UNITED STATES
DEPARTMENT OF THE INTERIOR
BUREAU OF LAND MANAGEMENT

SUNDRY NOTICES AND REPORTS ON WELLS
Do not use this form for proposals to drill or to re-enter an abandoned well. Use form 3160-3 (APD) for such proposals.

| 3b. Phone No. (include area code) Ph: 281-366-7148 | | 8. Well Name and No. GALLEGOS CANYON UNIT 368 |

BP America Production Company recently received approval for the Notice Of Intent to P&A the subject wellbore, but would like to submit the amended P&A procedure for the subject well.

Proposed Wellbore Diagram

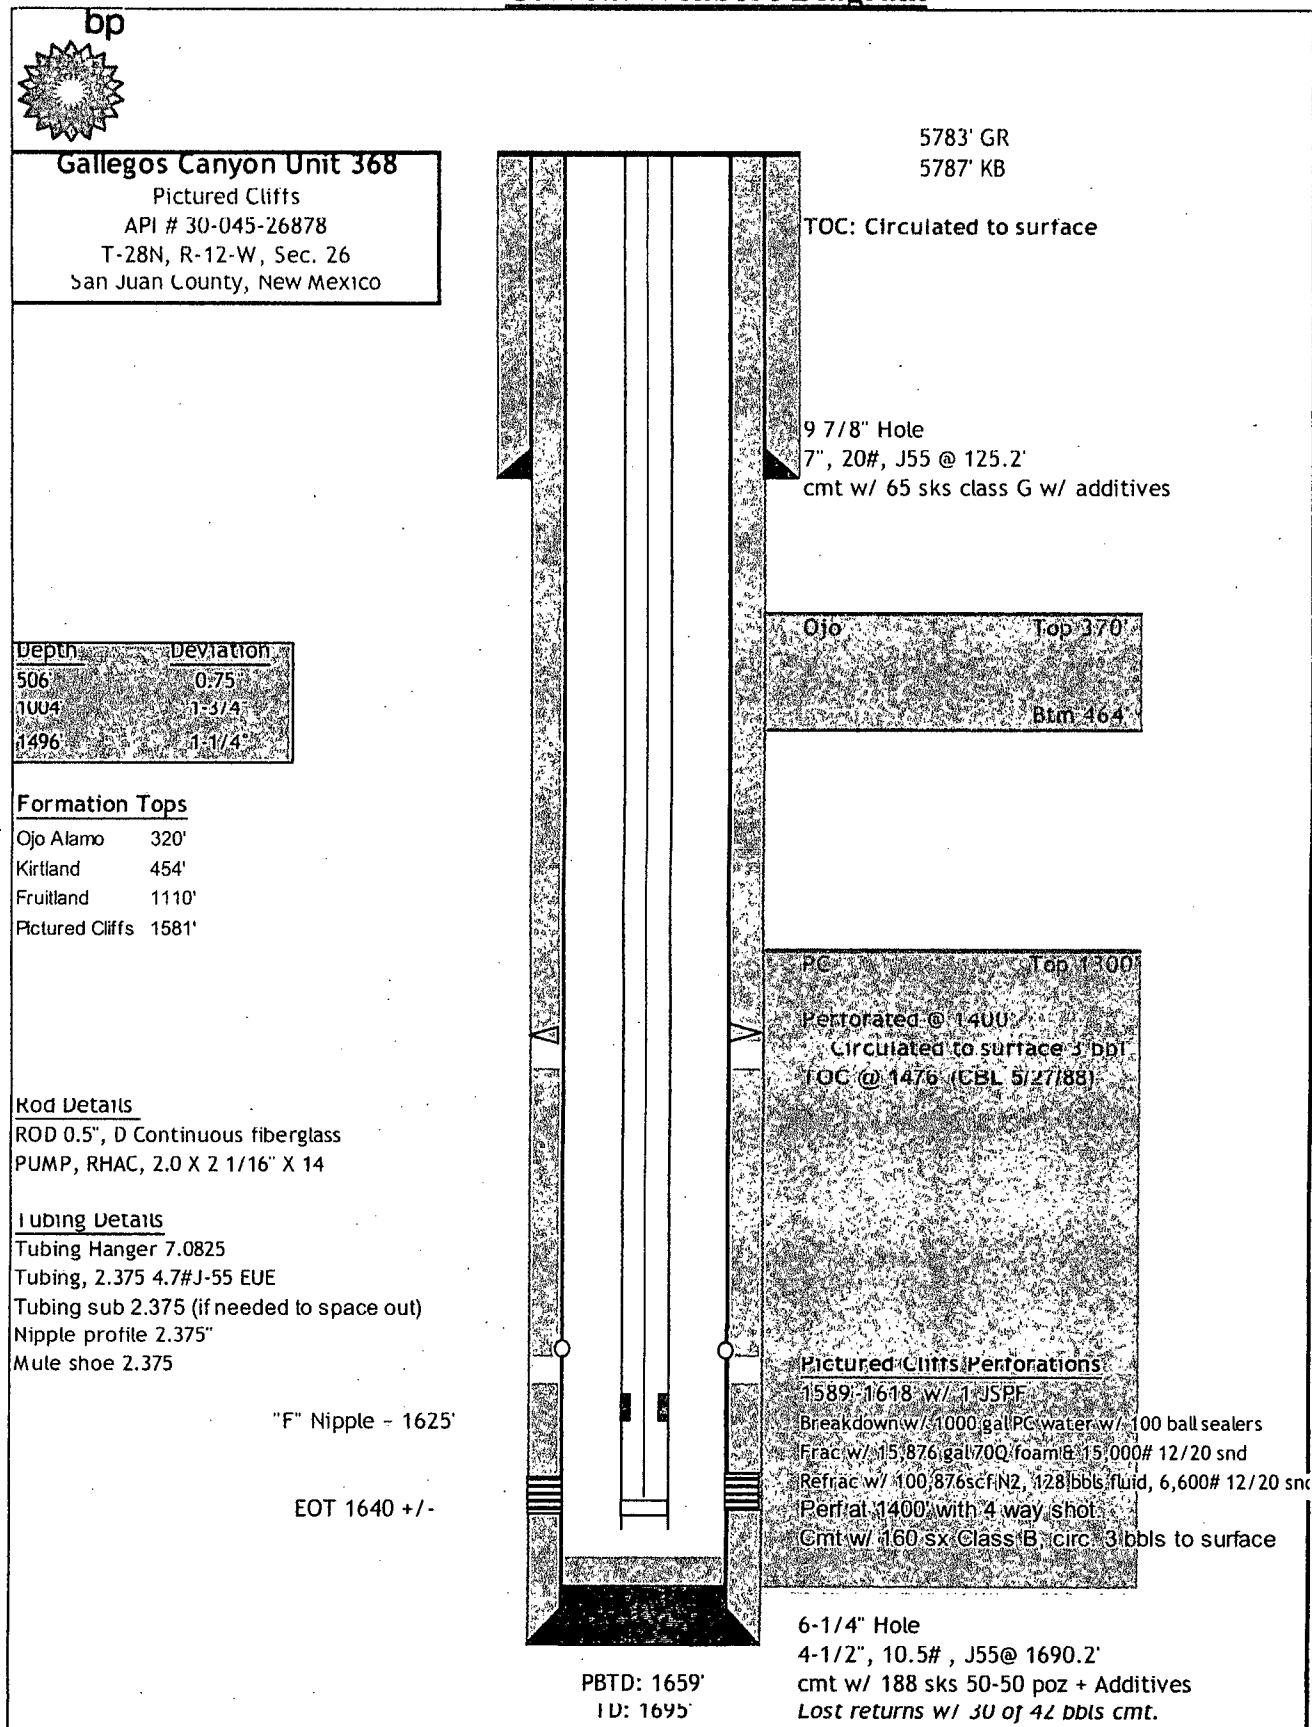
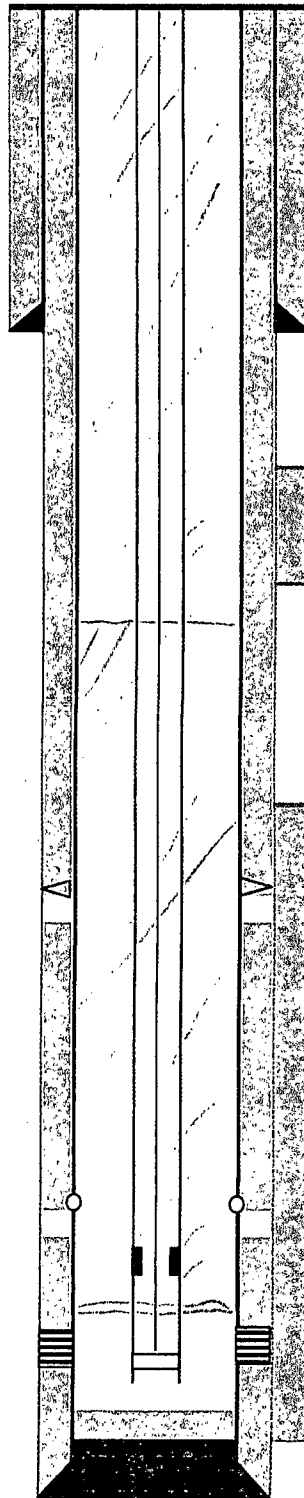
1. TOH with rods
2. TOH with completion.
3. RIH with 4.5" scrapper to 1600'
4. RIH with CIBP and set at 1550'
5. Balance plug to 550' with 78 sks (16 bbl) neat G cement
6. PU to 500' and reverse circulate.
7. RIH to 550' and balance cement to surface with 43 sks (8.8 bbl) cement.
8. Cut off well head, top off well in intermediate casing and install well marker and identification plate per regulatory requirements.
9. RD MO Location

$$550 / 11.167(1.15) = 43.5 \text{ sks}$$

$$1550 - 550 / 11.167(1.15) = 78.2 \text{ sks}$$

Plg, 1550 - 550

500 - surface
